# ONKYO SERVICE MANUAL

## QUARTZ SYNTHESIZED TUNER AMPLIFIER MODEL TX-15/TX-100

TX-15 Service Bulletin

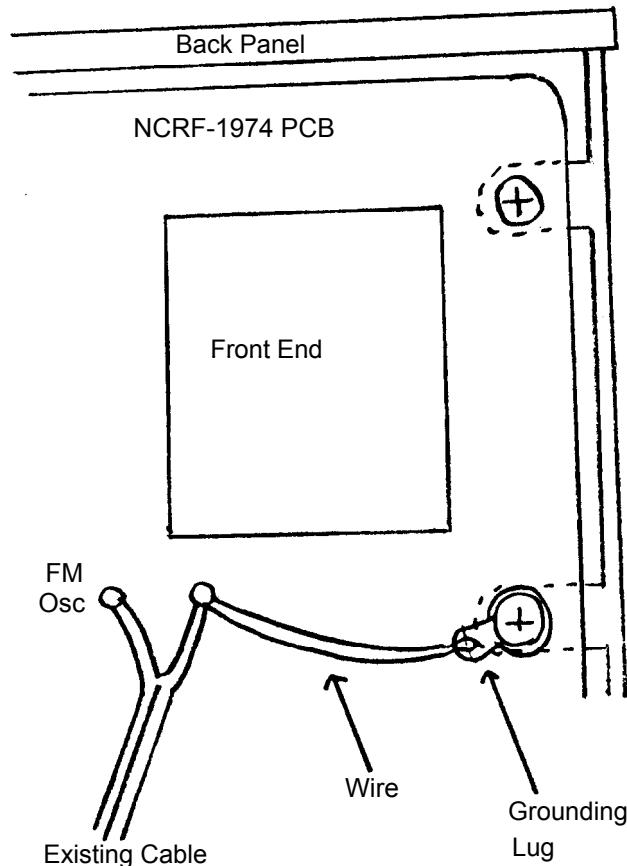
Problem: A loud hum or buzzing noise when listening to AM or FM.

Cause: Loose grounding screws on main printed circuit board NCRF-1974.

Solution: Add an additional grounding wire with lug from the ground post for the FM OSC cable to the chassis ground screw nearest it. Please see the below sketch.
